**TECHNICAL BULLETIN**  
**Bell Helicopter** **TEXTRON**

No. 222U-01-93

**MODEL AFFECTED:** 222U

**SUBJECT:** FUEL VENT ASSEMBLY P/N 430-060-004-101,  
INTRODUCTION OF

Figure 1. Vent Tube Modification

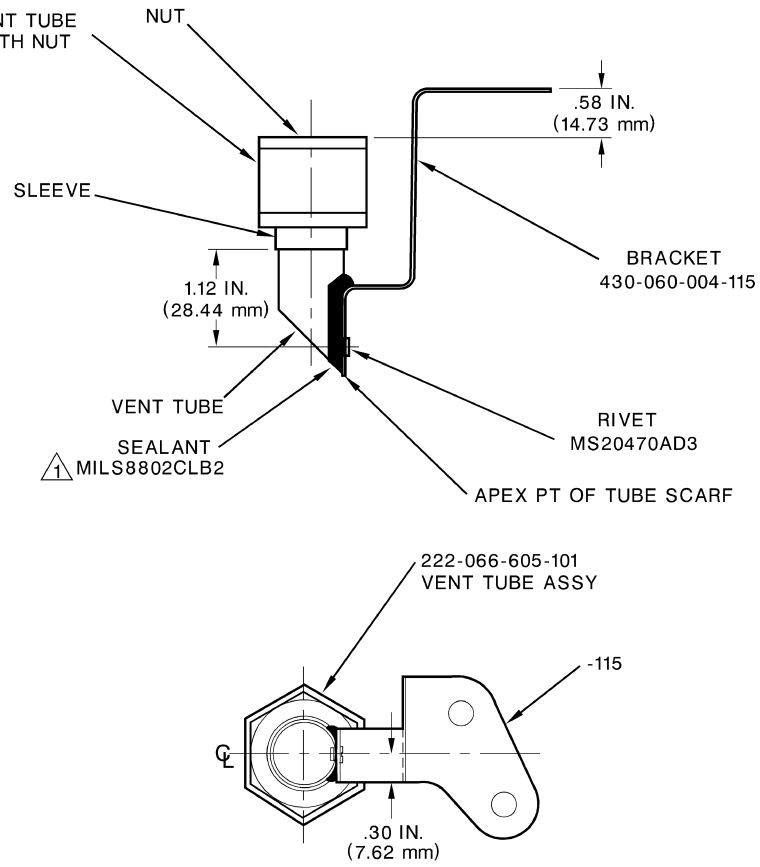
1. Remove existing fuel vent assembly P/N 222-066-605-101 from the prime pump plate. Refer to BHT-222U-MM-4, Chapter 28.
2. Modify fuel vent assembly as follows:
  - a) Ensure sleeve and vent tube is fully seated into the nut.
  - b) Install bracket on the vent tube using rivet MS20470AD3-length. Refer to figure 1 for details and dimensions.
  - c) Apply sealant (C-308) to fill the space between vent tube and bracket. Refer to figure 1.

ENSURE SLEEVE & VENT TUBE  
ARE FULLY SEATED WITH NUT

1 Apply MILS8802CLB2 (C-308) sealant to fill space between the vent tube and the bracket.

Figure 2. Vent Tube Installation

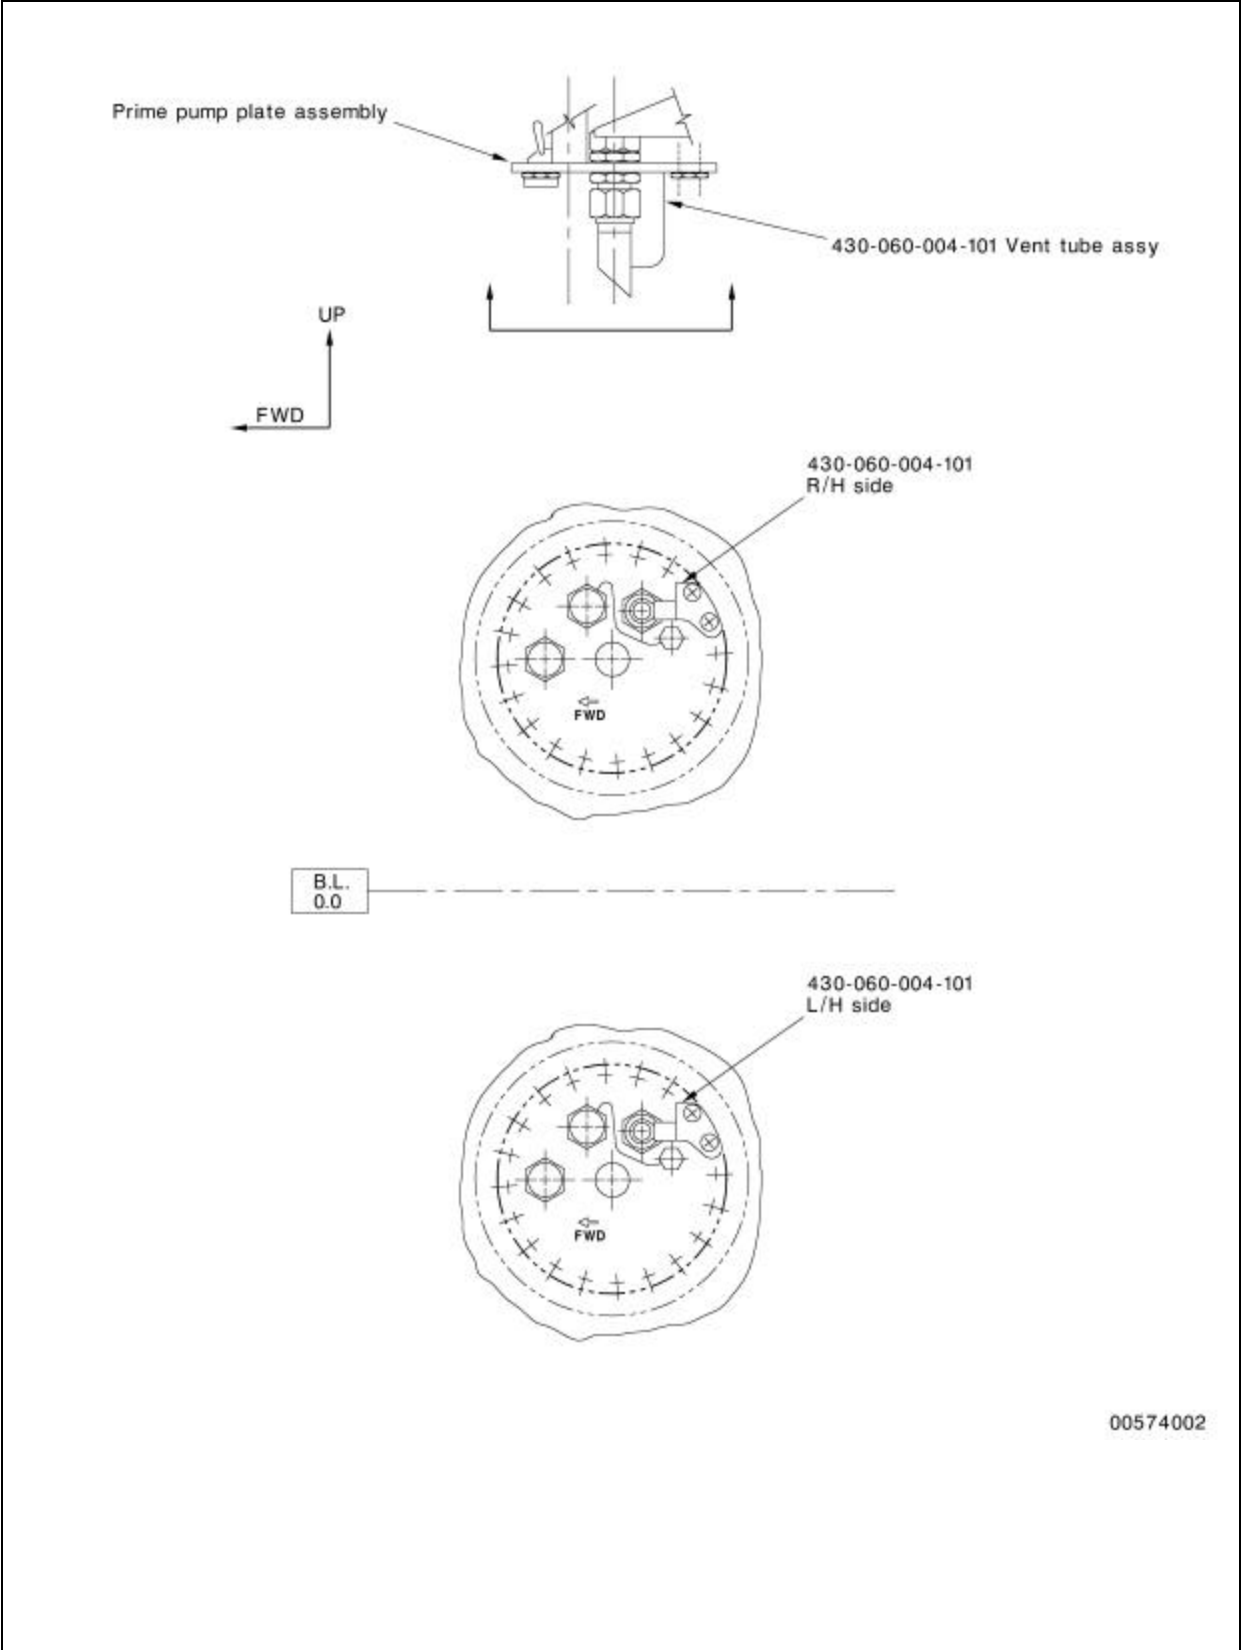
3. Remove two (2) prime pump plate retaining bolts and washers. Install modified fuel vent assembly or a new fuel vent assembly P/N 430-060-004-101 on the prime pump plate. Install retaining bolts and washers, previously removed, through the bracket and into the prime pump plate. Refer to BHT-222U-MM-4, Chapter 28 and figure 2.
4. Annotate aircraft records to reflect compliance with this bulletin.
